**PLANNED UNIT DEVELOPMENT
& SUBDIVISION STAFF REPORT****Date: October 19, 2017****DEVELOPMENT NAME**

PAM Mid Town Subdivision

Subdivision approval to create one legal lot of record and
Planned Unit Development approval to allow a new off-site
parking lot to accommodate an existing medical clinic.

SITE PLAN

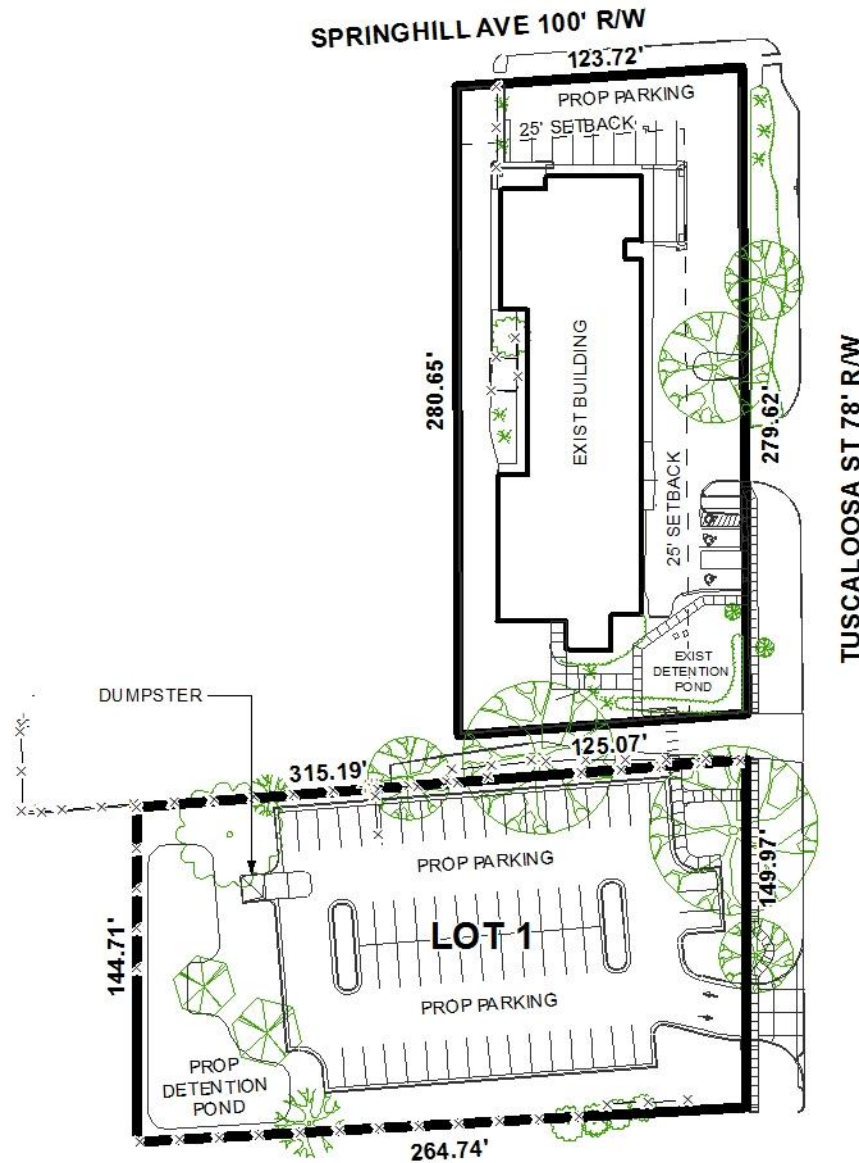
The proposed site plan will negatively impact access to the traffic signal that aligns with Stanton Road at Spring Hill Avenue. If this proposed development removes the asphalt on their property within the drive aisle, the traffic signal for that approach will have to be removed. The developer must coordinate with Traffic Engineering at time of construction for the City to remove the necessary equipment. The 2005 subdivision application for this site limited the corner parcel to the one shared driveway with the adjacent development. As a means of access management, the concrete pavement in the right-of-way of Spring Hill Avenue between the sidewalk and the curb should be removed and landscaped to prevent its use as a driveway. Also, the concrete apron for the drive aisle that is to be modified should be removed and grassed adjacent to the owner's property to further prevent its use as a two-way driveway. In conjunction with the signal removal, the City will designate the driveway portion remaining on the adjacent property as an entrance only driveway. New on-site parking, including ADA handicap spaces, shall meet the minimum standards as defined in Section 64-6 of the City's Zoning Ordinance.

The proposed lot has frontage on Tuscaloosa Street, a minor street with curb and gutter requiring a 50' right-of-way width. The preliminary plat illustrates a 78' right-of-way width at this location; therefore, no additional dedication should be required.

The 25' minimum building setback is illustrated on the preliminary plat and should also be retained on the Final Plat, if approved.

With regards to access management, a note should be placed on the Final Plat, if approved, stating the lot is limited to one curb cut to Tuscaloosa Street, with any changes to its size, location or design to be approved by Traffic Engineering and conform to AASHTO standards.

A house and structural remains are illustrated on the preliminary plat; therefore, it should be noted that demolition permits will be required to remove the existing house prior to the approval of any other construction or land disturbance requests.

The site plan illustrates 11 on-site parking spaces and 62 off-site parking spaces which, when combined, meet the minimum off-street parking requirements regarding number of parking spaces, and stall length and width. Three on-site parking spaces are designated as van accessible and also meet dimensional requirements.

Curbing is illustrated where vehicles could extend beyond existing and proposed parking facilities.

Adequate 24' two-way aisle access and a 24' wide driveway providing access to and from Tuscaloosa Street are illustrated for the proposed parking lot. It should be noted however, that similar aisle configuration on the original PUD property is, at times, reduced by one (1) to seven (7) feet. While access and maneuvering may not meet current requirements, the site was previously expanded in compliance with the approved Administrative PUD.

A note has been placed on the site plan iterating compliance with parking lot lighting requirements per Sections 64-4.A.2. and 64-6.A.3.c. of the Zoning Ordinance, but a photometric plan showing compliance with Section 64-6.A.8. will nevertheless be required prior to the approval of any land disturbing or construction activities.

A proposed sidewalk is illustrated on the site plan along Tuscaloosa Street where the proposed lot has frontage; and existing sidewalks along both streets to which the original PUD site has frontage are also illustrated. Also, a pedestrian safety walkway is proposed across 20' of the adjacent property, thus providing safer access between the two sites regarding traffic to and from Tuscaloosa Street.

While landscape area appears to meet the minimum applicable requirements, Staff cannot determine compliance with the tree requirements. Tree credit data is not clearly identified and it appears that several off-site trees are being included for credit. As such, revision of the Tree and Landscape plan to adequately identify the amount and types of trees on site will be required prior to the approval of any land disturbing or construction activities.

It should also be noted that any changes to the site plan as a result of comments from Traffic Engineering will need to be illustrated on a revised site plan.

A dumpster pad is depicted on the site plan along with a note stating compliance with Section 64-4.D.9. of the Zoning Ordinance regarding enclosure and sanitary sewer connection requirements. This information should be retained on any revised site plan; or, if necessary, a note stating curbside pickup will be utilized instead may suffice.

Finally, the site is adjacent to several R-1, Single-Family Residential properties, thereby requiring a residential buffer in compliance with Section 64-4.D.1. of the Zoning Ordinance. A 6' wooden privacy fence is illustrated on the site plan where the site abuts residential property and is sufficient to comply with these buffer requirements, but the applicant should note that a separate building permit will be required for any fence(s) constructed on the property.
